Surplus Plutonium Disposition Final Environmental Impact Statement Comment Response Document Volume III - Part B

November 1999

Title: *Surplus Plutonium Disposition Final Environmental Impact Statement (SPD EIS)* (DOE/EIS-0283)

Fig. 5-2 Heat Generation of Spent UO₂ and MOX Fuel

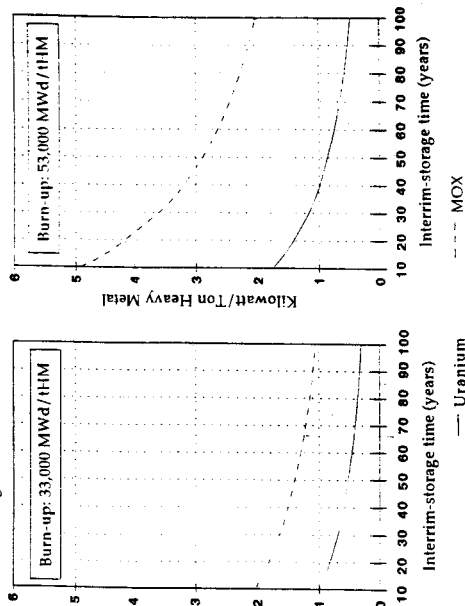
8.) Decay Heat

I reference the International MOX Assessment report entitled the Comprehensive Social Impact Assessment of MOX Use in Light Water Reactors by J. Takagi et.al., 1997 by Pub. Citizens Nuclear Information Center, Tokyo, Japan, page 190 shows the following table for decay heat generation is presented:
